Eastern Bays Shared Path project

Memorandum 5 – Response to matters raised in email dated 6 March 2020

This Memorandum 5 is the fifth memorandum submitted by Stantec, on behalf of Hutt City Council, to respond to the further information request received from Greater Wellington Regional Council and Hutt City Council. This memorandum responds to matters raised in the email dated 6 March 2020 from Shannon Watson. The email summarises key issues that the respective councils have identified and summarised.

Figure 5.13 of Clause 5.5.3 of the Austroads Guide to Road Design Part 6A recommends the following typical detail for flared bicycle rail terminal ends:

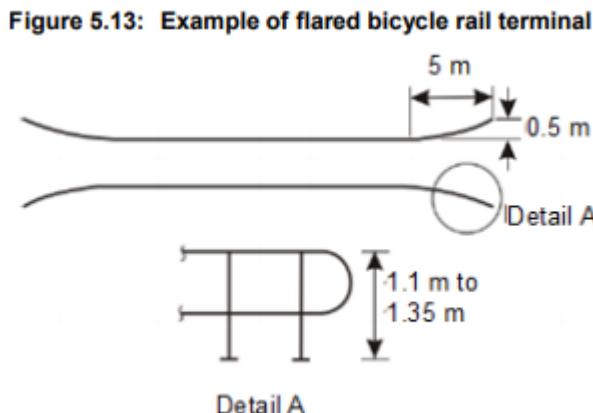
The proposed intermittent barrier approach at high wall sections potentially introduces an increased likelihood of spearing or end collision hazards for pedestrians and cyclists. It also presents similar risks for errant motor vehicles particularly considering a significant proportion of the project has a speed limit of 70km/h. Careful consideration should also be given to the bicycle rail system terminal end details to ensure that the required protection of the roadside hazard is either continuous, or where intermittent, meets the design intent and does not overly compromise shared path width or introduce hazards that could prove more hazardous.

In order to accommodate the above terminal flares on intermittent barriers lengths along the top of the seawall would result in a significant reduction in available shared path width over localised sections of the shared path. A careful balance will need to be struck between user safety from falling and safety from collision due to a less than desirable overall shared path width.

Moving barrier out to extreme nose of seawall

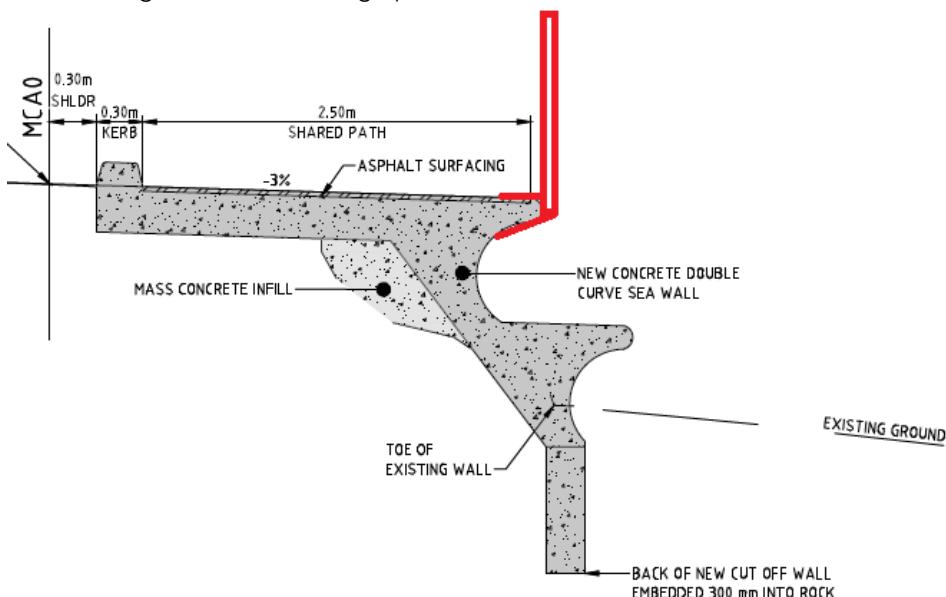
Fixing the barrier support posts to the outside edge of the nosing on the upper curved section would provide the maximum shared path width. The sketch below is a typical arrangement that could be explored in more detail during the detailed design phase:

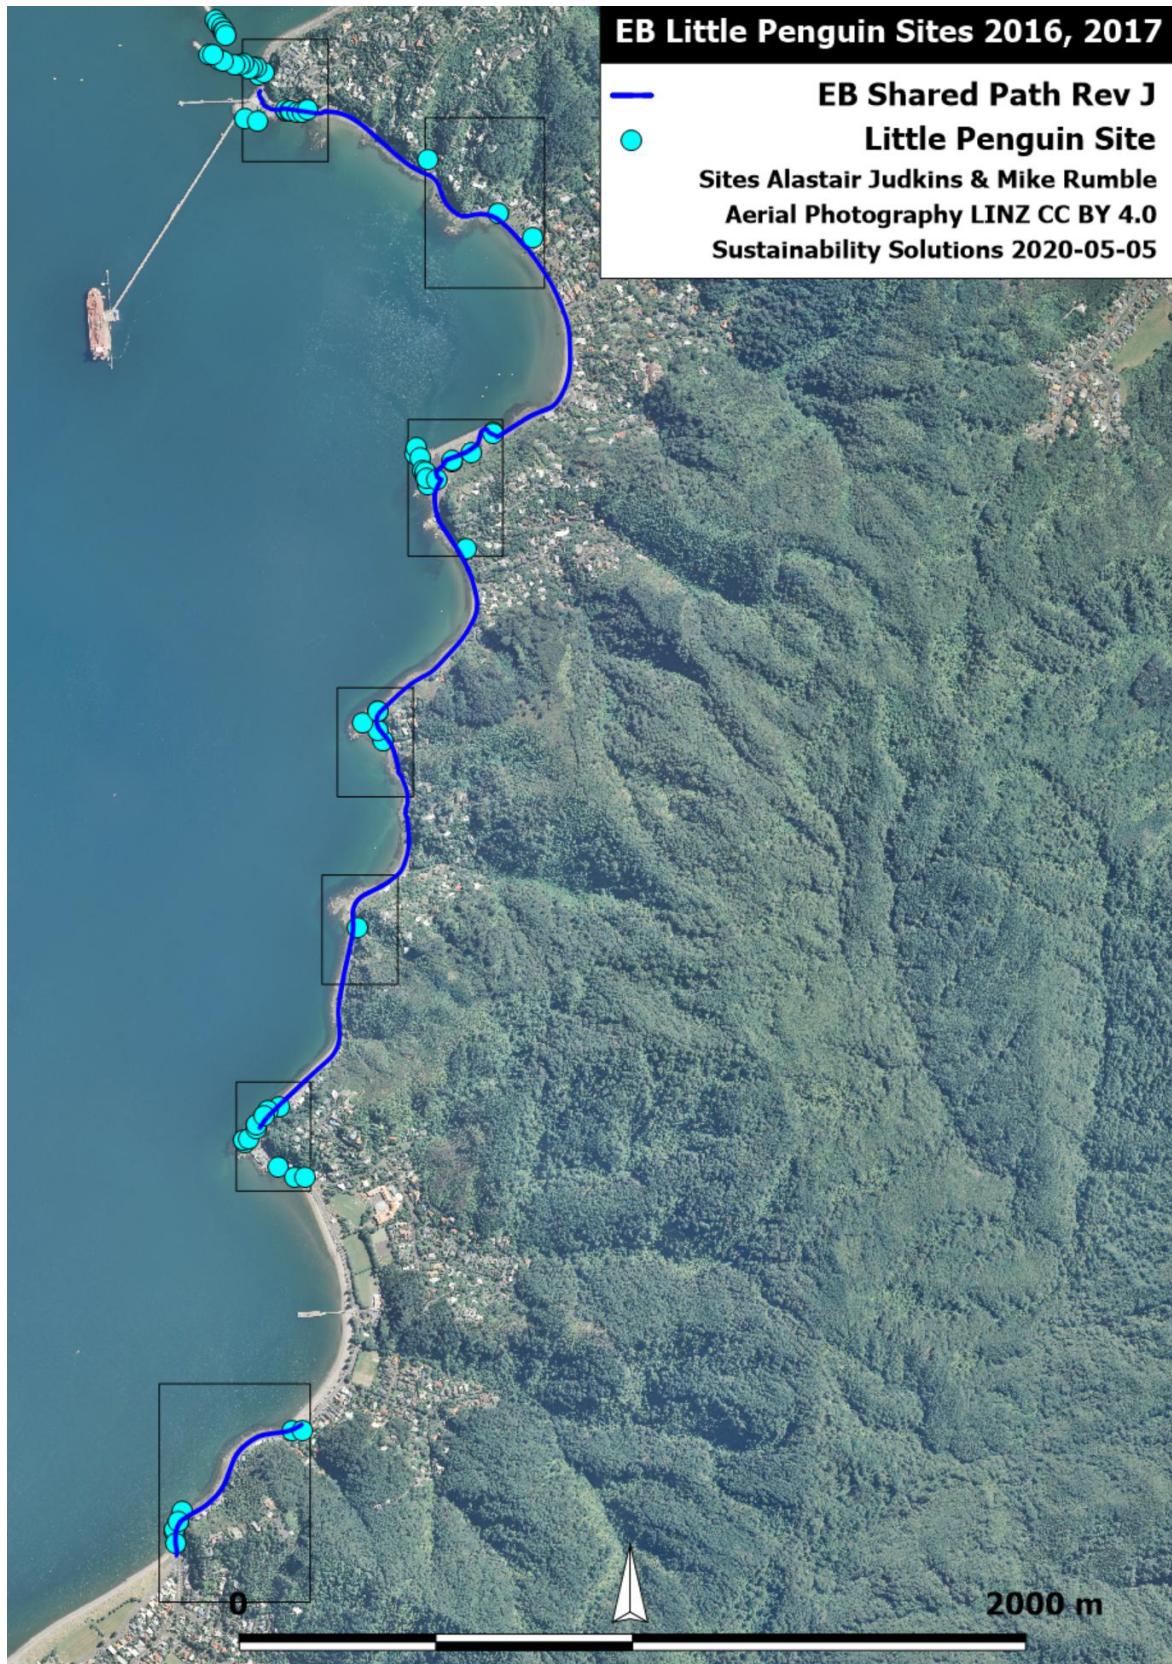
To be able to provide more guidance Dr Uys confirms he requires (*I understand he also raised this in the meeting*):

- Confirmation on the number of confirmed penguin nests within the project footprint
- More detailed information/methodology on how penguins will be managed during construction – this could be incorporated into a CEMP, as suggested in the comments on sub/inter-tidal ecology.

Appendix C-1 of the resource consent application sets out the assessment of the proposed shared path on penguins. The following map shows the location of the nests. This information was not included in the assessment given that it would be in the public domain and it was considered by the author to pose a risk to the nests.

Table 8-1 of Appendix C-1 of the resource consent application summarises results of the penguin surveys undertaken. There is a total of 35 nests within the Shared Path project area (2017 data) which includes those on both the landward and seaward sides of Marine Drive. Those that are within the 'project footprint' (seaward side of Marine Drive) are estimated to be 29 nests. It is noted that there are **no nests within the footprint of the shared path.**
